City of **HOBART**

## APPLICATION UNDER HOBART INTERIM PLANNING SCHEME 2015

Type of Report:	Committee
Committee:	15 February 2023
Expiry Date:	16 February 2023
Application No:	PLN-22-736
Address:	487 SANDY BAY ROAD , SANDY BAY 489 SANDY BAY ROAD , SANDY BAY
Applicant:	Daniel Cripps (Leary, Cox and Cripps) G04, 40 Molle Street
Proposal:	Subdivision (Boundary Adjustment)
Representations:	None
Performance criteria:	General Residential Zone Development Standards for Subdivision, and Historic Heritage Code

Figure 2: The originally proposed subdivision showing the lot boundary (in red) in line with Council's heritage advice.

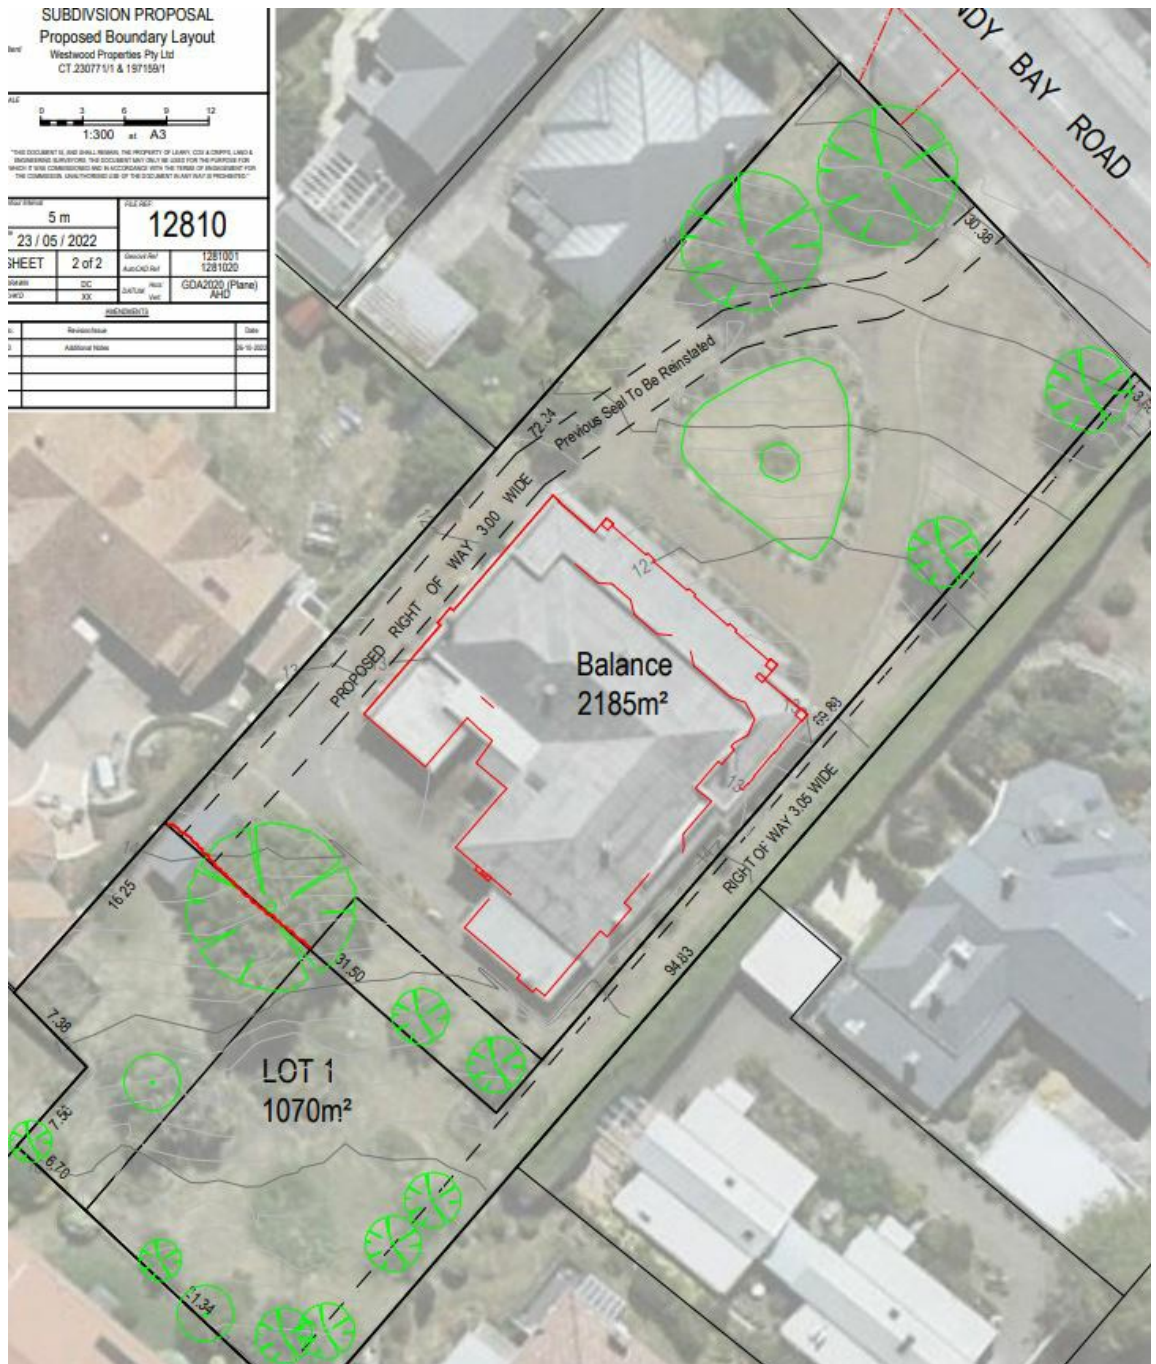
4.1 The applicant sought pre-application advice from Council regarding the proposed boundary adjustment through PAE-22-260 in October 2022. At this time, heritage advice was provided that a rear boundary for the front, heritage listed, dwelling be located a minimum of approximately 8m from the rear of the building.

4.2 When the application was initially submitted, this reflected the heritage advice provided in PAE-22-260, showing the boundary in the location recommended.

Figure 3: The advertised plan showing the new boundary (in blue), not in accordance with Council's heritage advice.

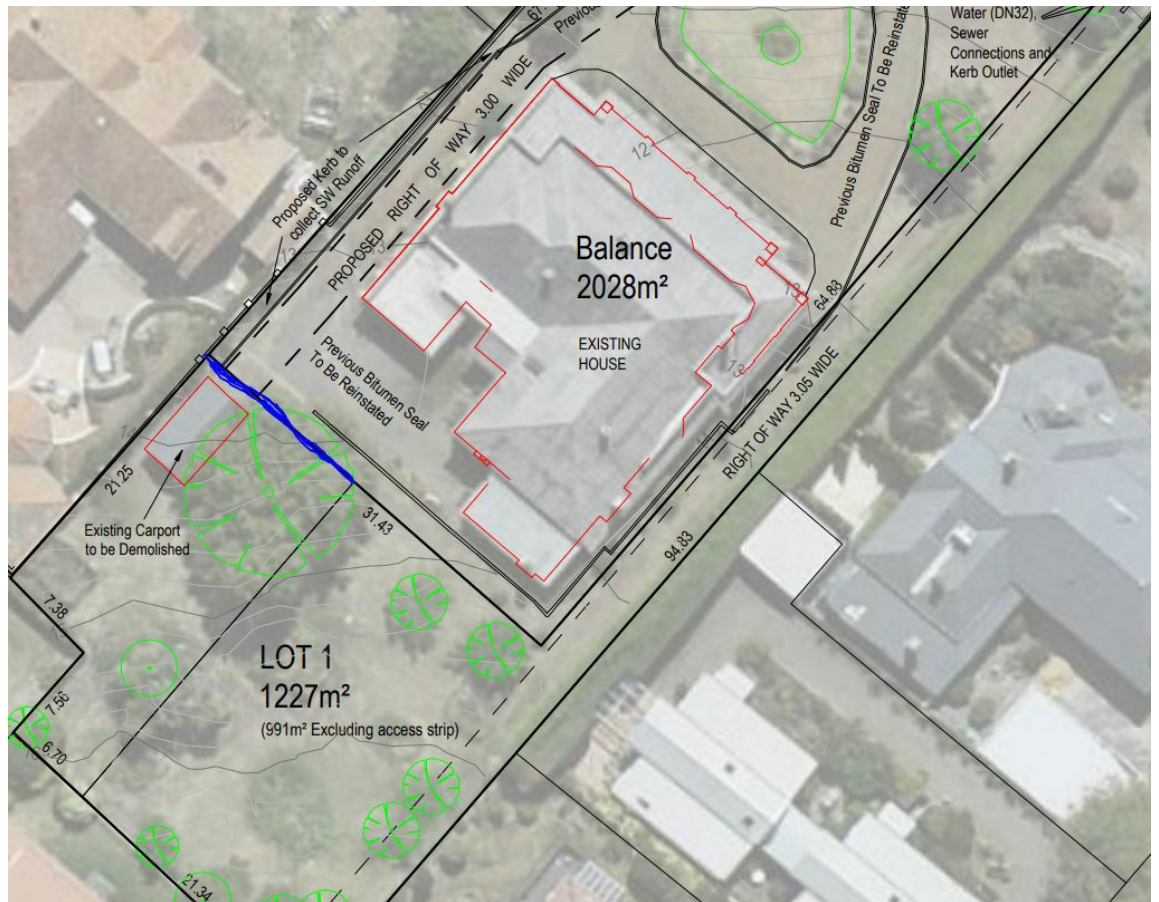
- 4.3 An unrelated request for additional information resulted in the location of the boundary being moved 5m closer to the heritage listed dwelling without consultation with Council officers, and the proposed boundary was advertised in this new location.

- 4.4 Following advertising, in the detailed assessment of the proposal, the change to the plans was identified, and the applicant contacted to discuss it and the fact that it rendered the application difficult to support from a heritage perspective.
- 4.5 The applicant considered their options, came up with a potential alternative subdivision design (below) and sought independent heritage advice on this and the advertised design. The amended design gives the access strip from 489 Sandy Bay Road (the rear lot) to 487 Sandy Bay Road (the front lot), retaining it as a service easement for 489 Sandy Bay Road (the rear lot), but critically it does not address the heritage concerns regarding the proximity of the lot boundary to the rear of the heritage listed dwelling on 487 Sandy Bay Road.

*The curtilage of the dwelling would be significantly reduced by the proposed subdivision and it is considered to be insufficient. The proposal will diminish the significance and setting of the residence*

*as identified in the statements of significance. The subdivision is a clear separation of the dwelling from its original setting providing little to no rear curtilage or garden setting. The proposed rear setback from the residence of only 2.7m, this is considered inadequate and will not prevent unsympathetic development on lots adjoining any titles containing heritage values. The heritage consultant engaged by the applicant shares these concerns “I do have concerns that the proposed boundary is too close to the rear of the existing heritage residence. I feel that the place would benefit from a larger rear curtilage (say +4-5m than what is proposed) to allow for retained backyard amenity and to retain some of the backyard setting of the building”.*

Figure 4: Applicant's post-advertising alternative design which was provided to accompany the post advertising heritage advice.

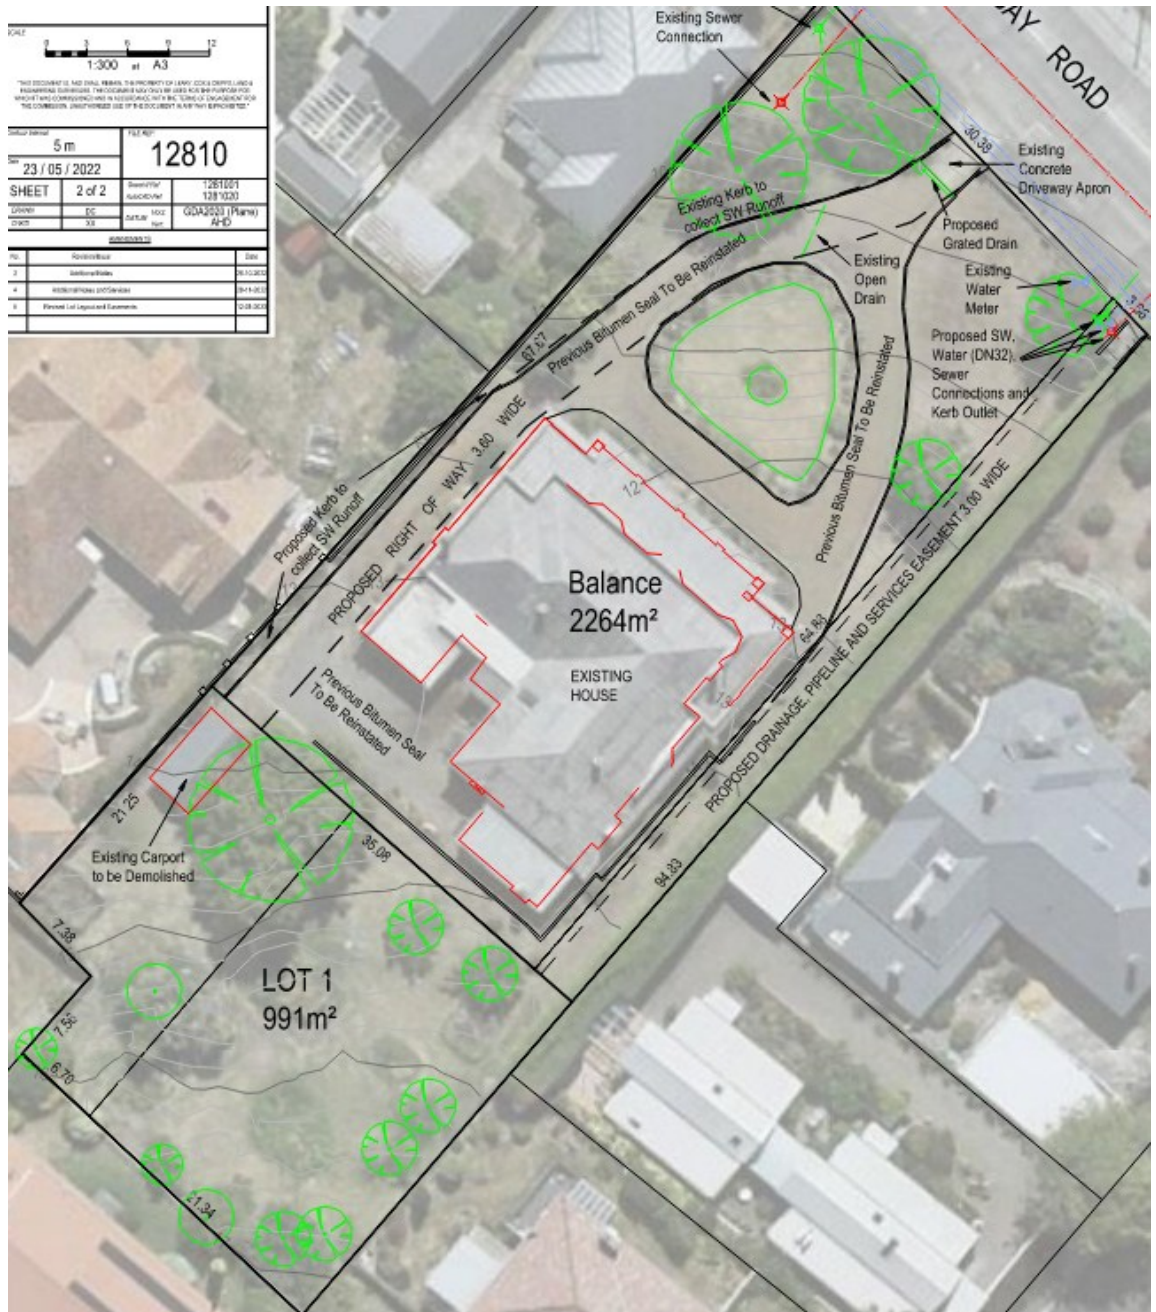
4.6 Amongst other things, this independent heritage advice confirms Council's Cultural Heritage Officer advice that the boundary location is not appropriate with respect to the heritage listed dwelling. This advice is an attachment to the report. Its concluding paragraph states as follows:

*I do have some concerns that the proposed boundary is too close to the rear of the existing heritage residence. I feel that the place would benefit from a larger rear curtilage (say +4-5m than what is proposed) to allow for retained backyard amenity and to retain some of the backyard setting of the building. That said, the proposal provides less impact upon the curtilage and amenity of the building than the current situation which allows for a driveway very close to the eastern side of the building.*
